**PCO #038**

**Project:** 21-501 - Collin County Adult Detention Facility, Phase 1 Addition  
 4300 Community Avenue  
 McKinney, Texas 75071

**Prime Contract Potential Change Order #038: PR #9R Future Ductwork and Raceways at Female Shell Out Space**

**PROJECT:** Collin County Adult Detention Facility **PROPOSAL REQUEST 09R**  
4300 Community Avenue  
McKinney, TX 75071

**2 LEVEL 1 WEST FLOOR PLAN - LIGHTING - ALT #1**  
1/8" = 1'-0"

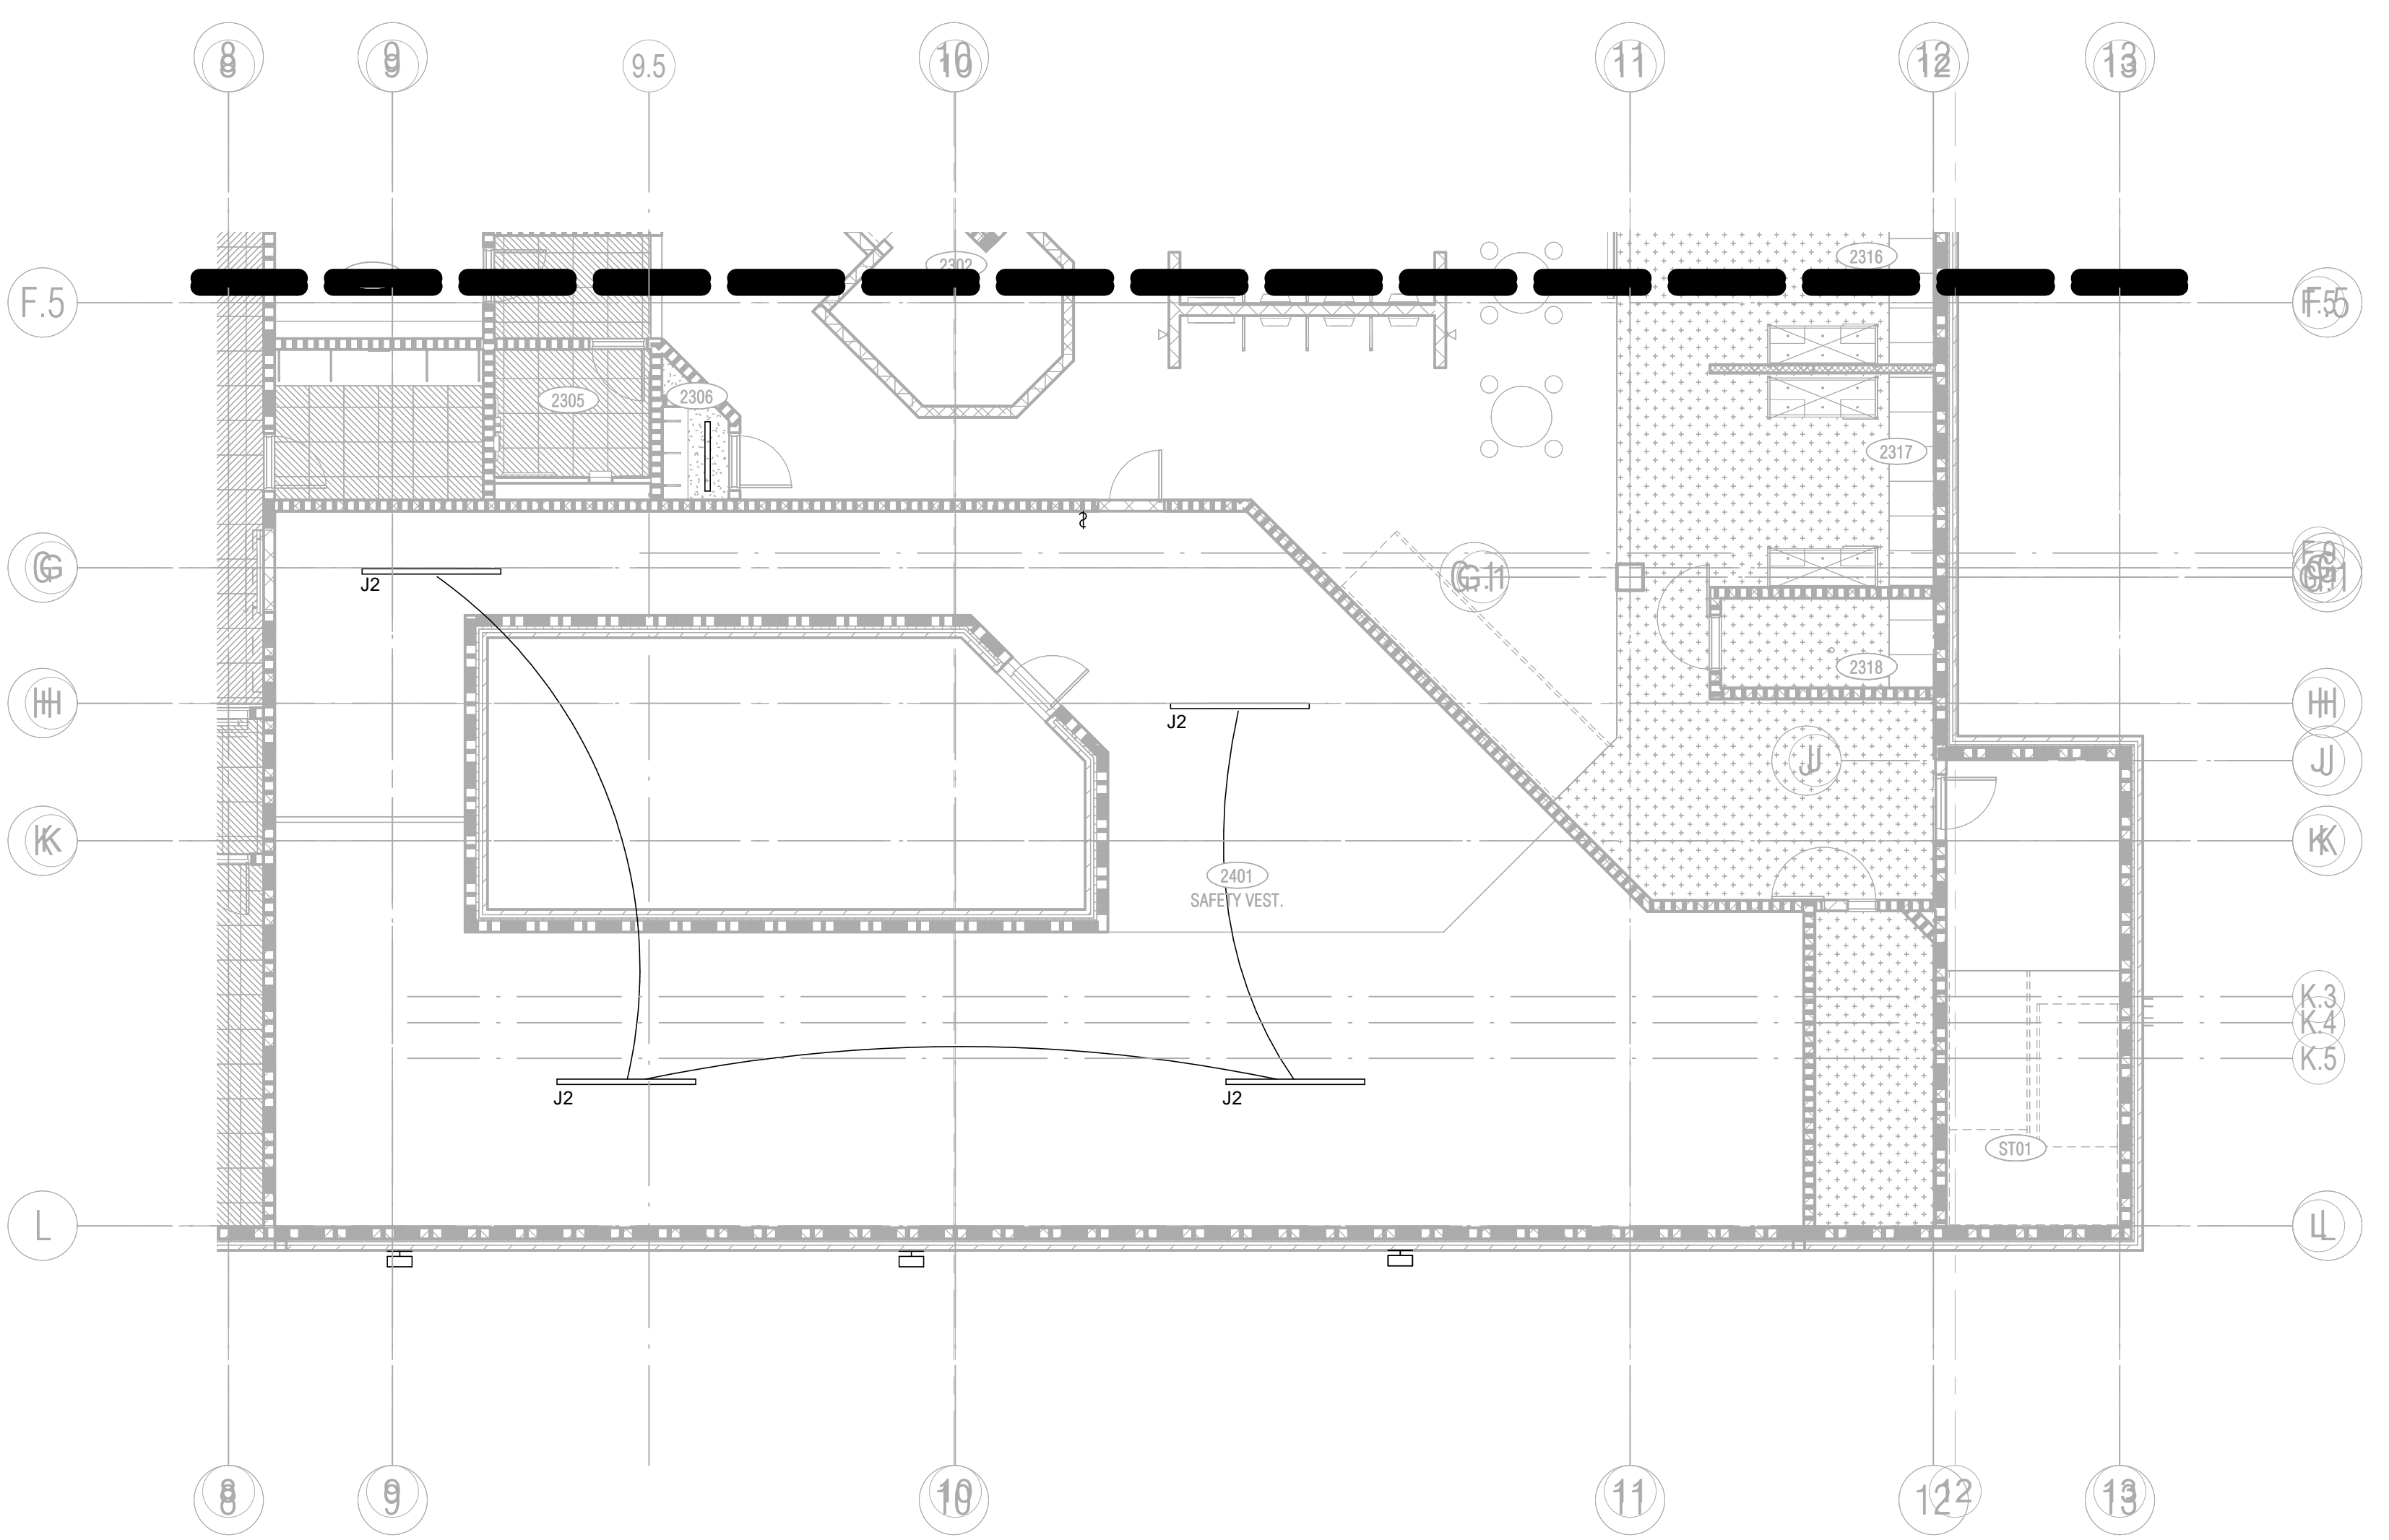
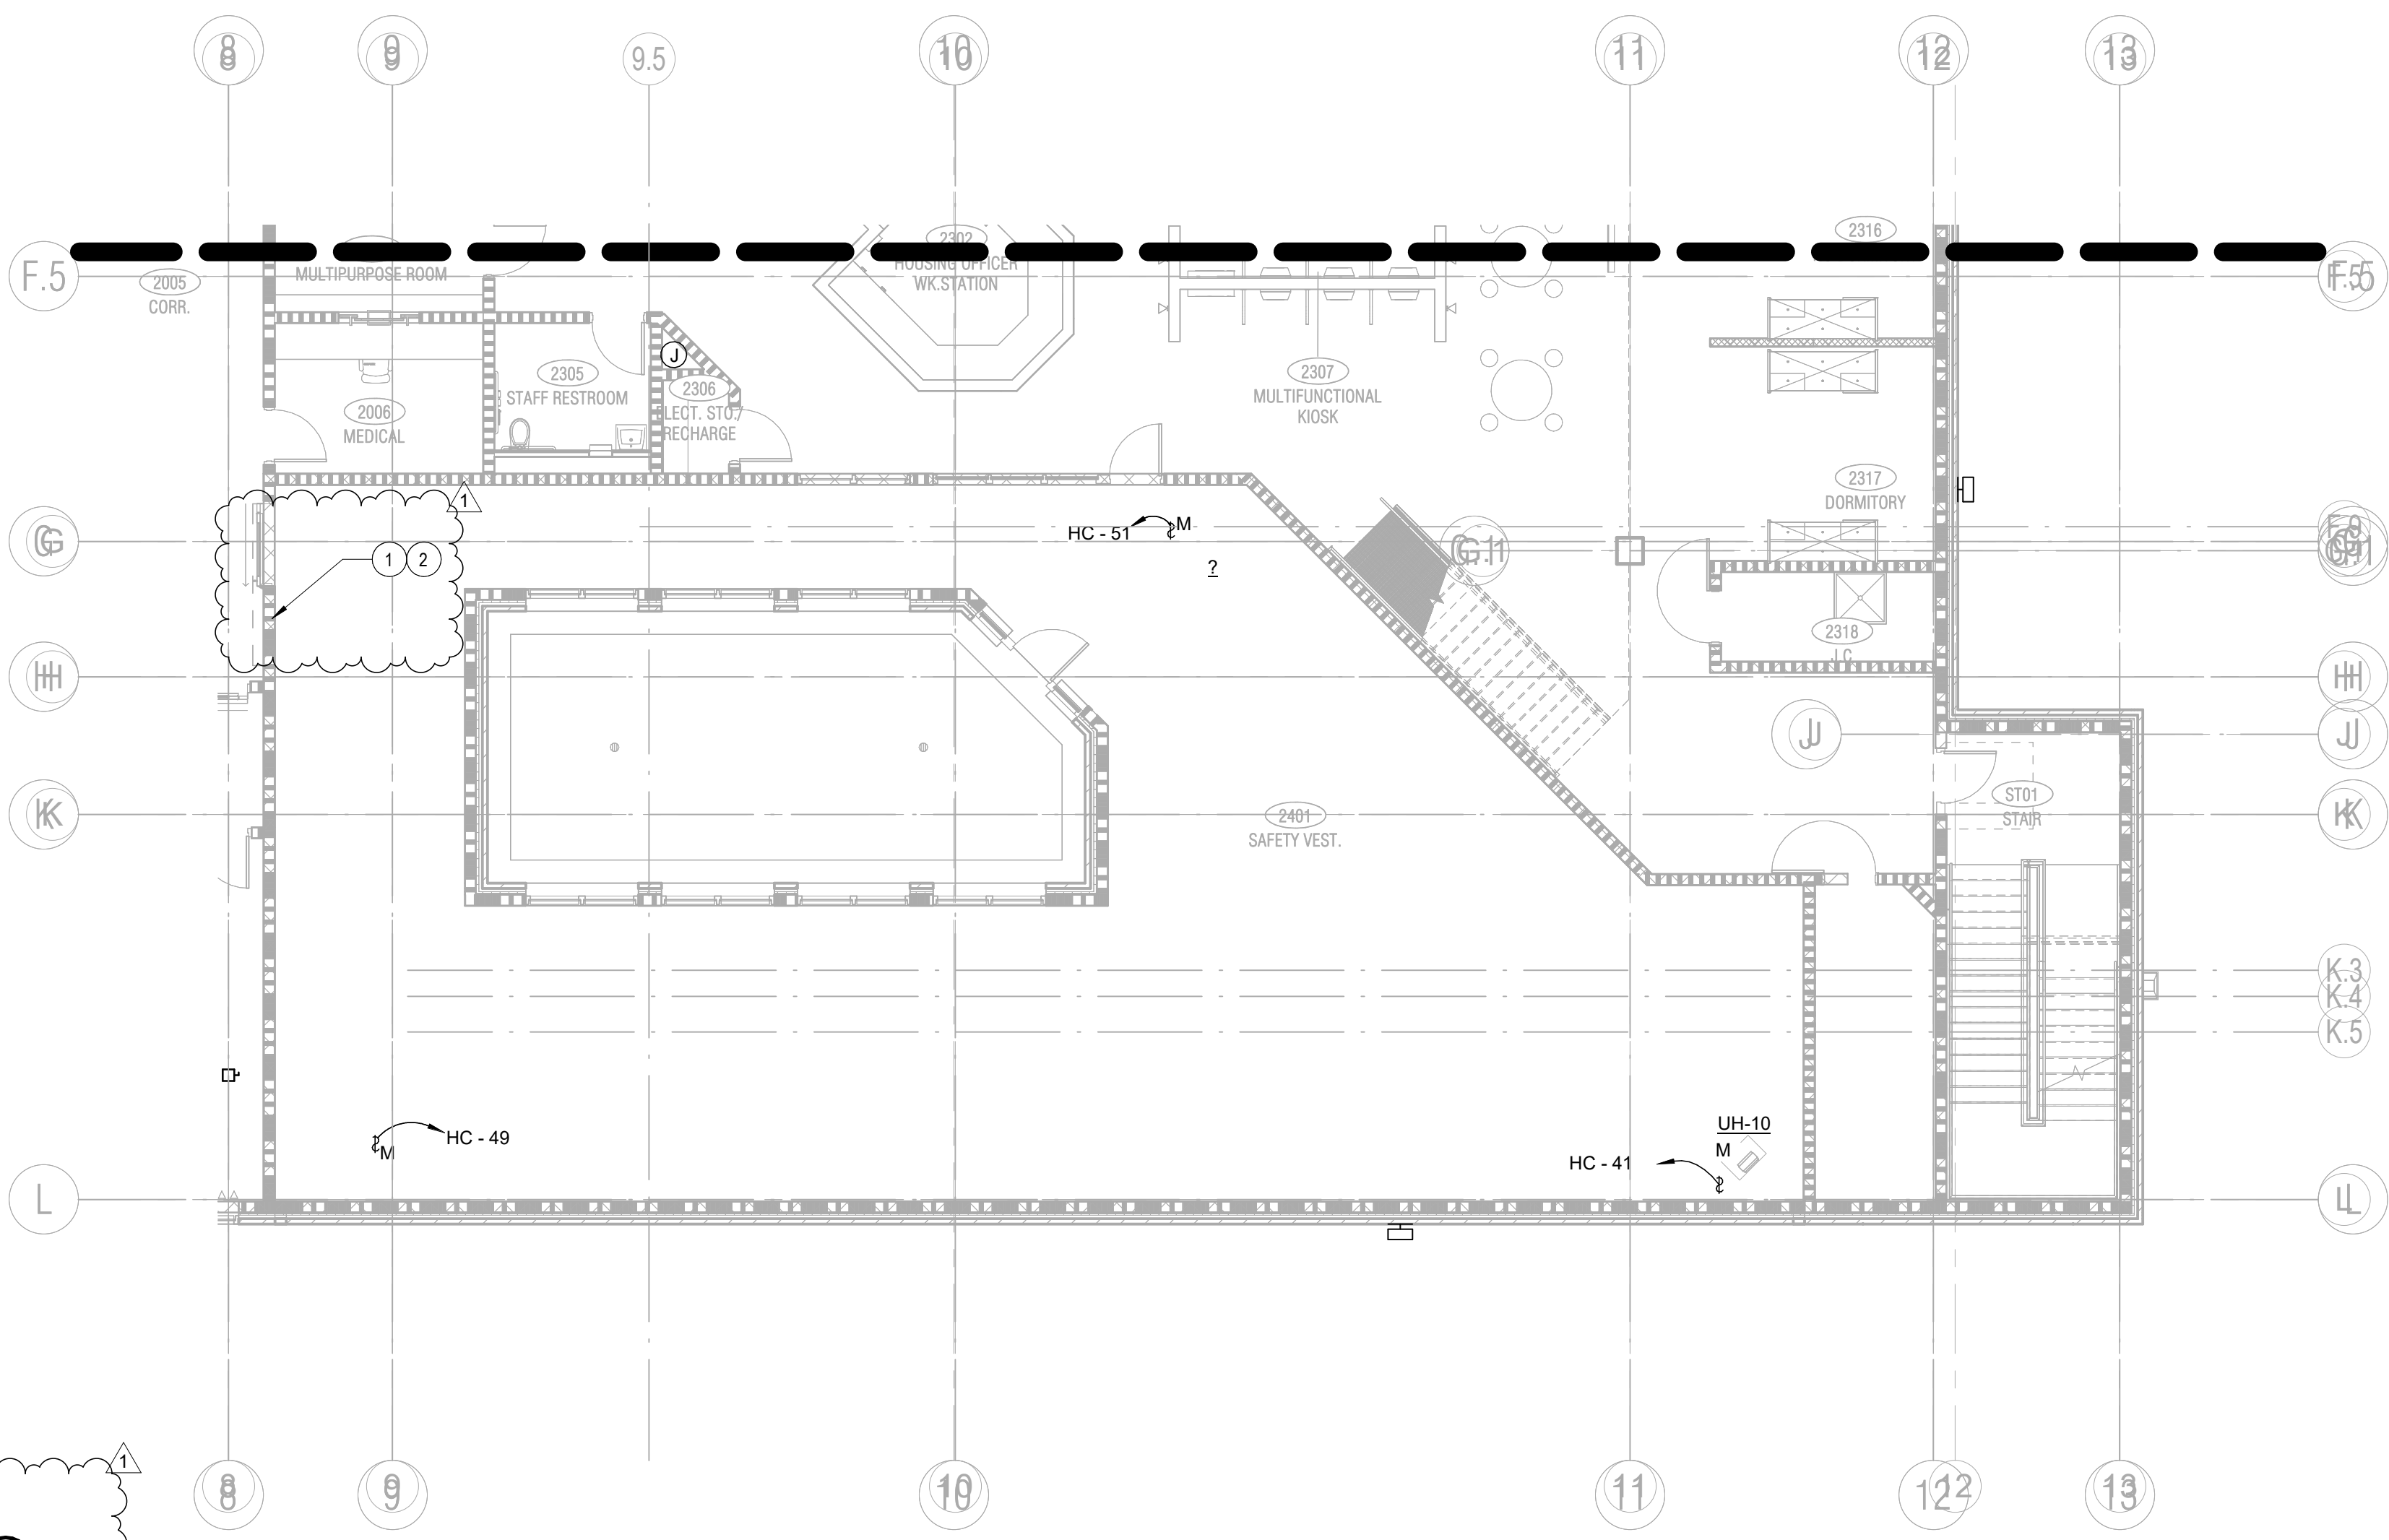
- PROVIDE (4) 1" CONDUITS WITH PULL STRING BACK TO PANEL LC FOR FUTURE POWER. PROVIDE PULL BOXES AS REQUIRED. E701
- PROVIDE (3) 1" CONDUITS WITH PULL STRING BACK TO PANEL HD FOR FUTURE LIGHTING. PROVIDE PULL BOXES AS REQUIRED. E701

① LEVEL 1 WEST - FLOOR PLAN - IT  
1/8" = 1'-0"

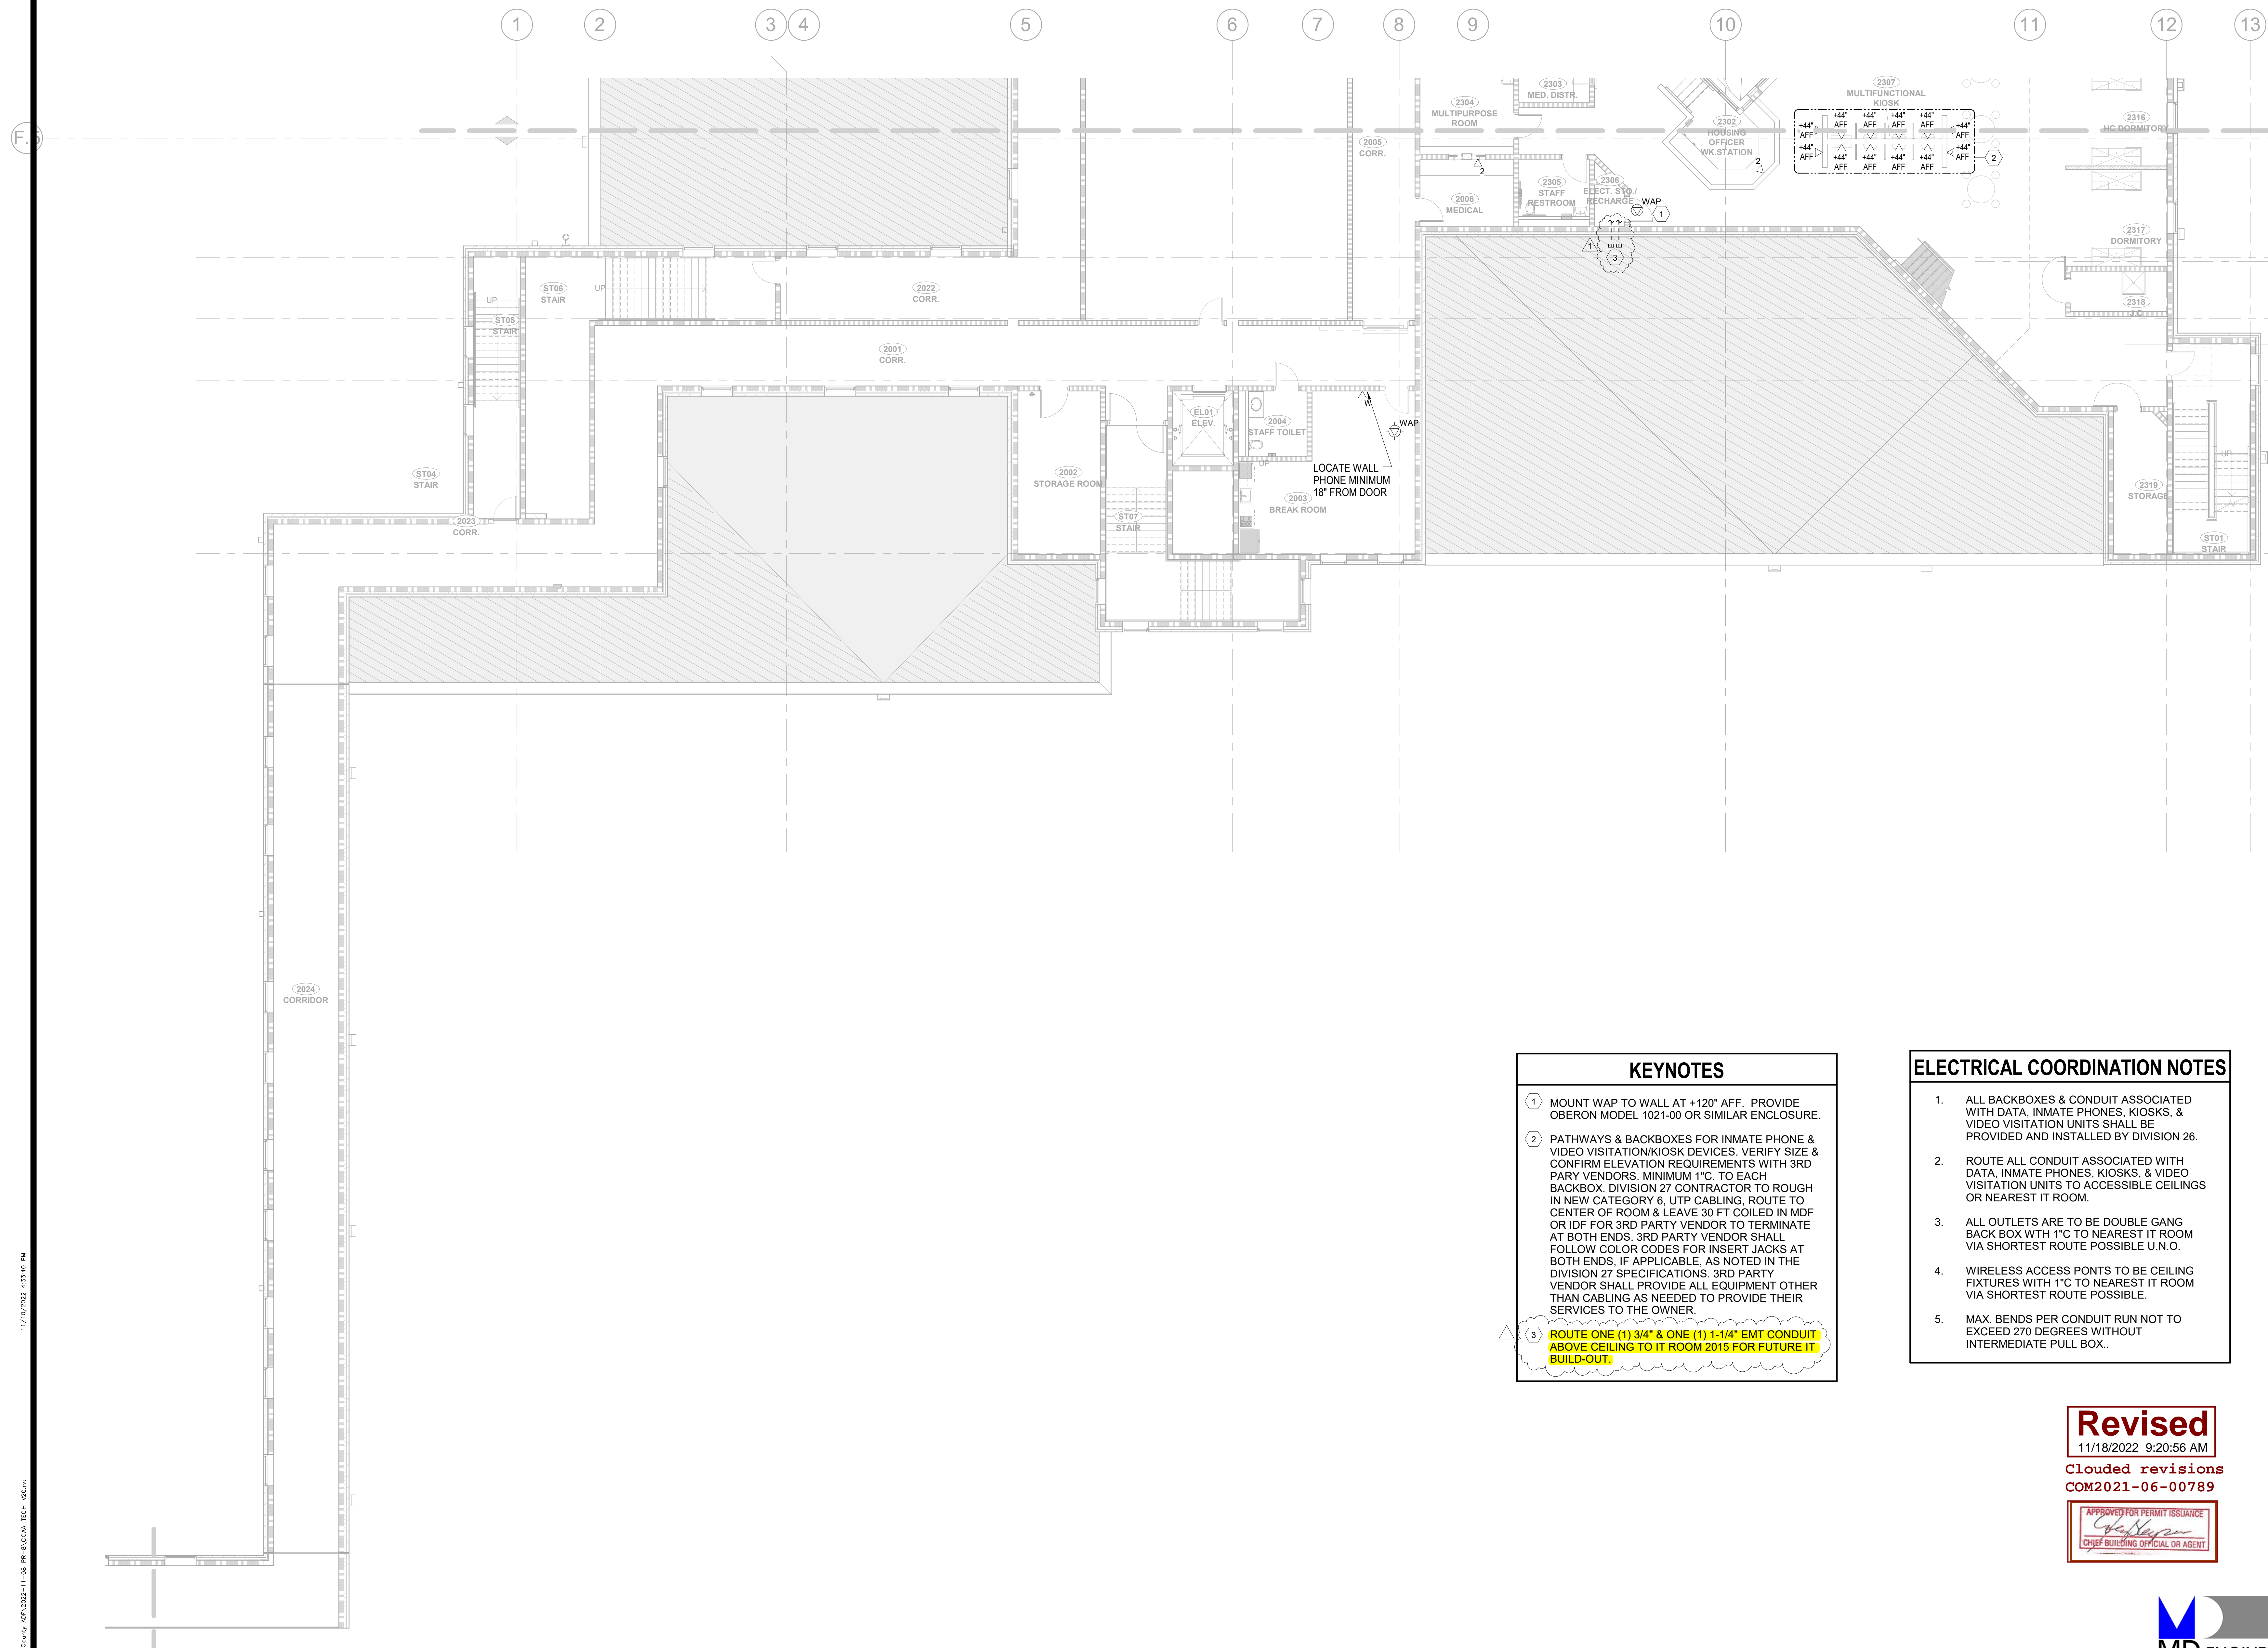
- ① MOUNT WAP TO WALL AT +120" AFF. PROVIDE OBERON MODEL 1021-00 OR SIMILAR ENCLOSURE.
- ② PATHWAYS & BACKBOXES FOR INMATE PHONE & VIDEO VISITATION/KIOSK DEVICES. VERIFY SIZE & CONFIRM ELEVATION REQUIREMENTS WITH 3RD PARTY VENDORS. MINIMUM 1" C. TO EACH BACKBOX. DIVISION 27 CONTRACTOR TO ROUGH IN NEW CATEGORY 6, UTP CABLING, ROUTE TO CENTER OF ROOM & LEAVE 30 FT COILED IN MDF OR IDF FOR 3RD PARTY VENDOR TO TERMINATE AT BOTH ENDS. 3RD PARTY VENDOR SHALL FOLLOW COLOR CODES FOR INSERT JACKS AT BOTH ENDS, IF APPLICABLE. AS NOTED IN THE DIVISION 27 SPECIFICATIONS. 3RD PARTY VENDOR SHALL PROVIDE ALL EQUIPMENT OTHER THAN CABLING AS NEEDED TO PROVIDE THEIR SERVICES TO THE OWNER.
- ③ ROUTE ONE (1) 3/4" & ONE (1) 1-1/4" EMT CONDUIT ABOVE CEILING TO IT ROOM 2015 FOR FUTURE IT BUILD-OUT.
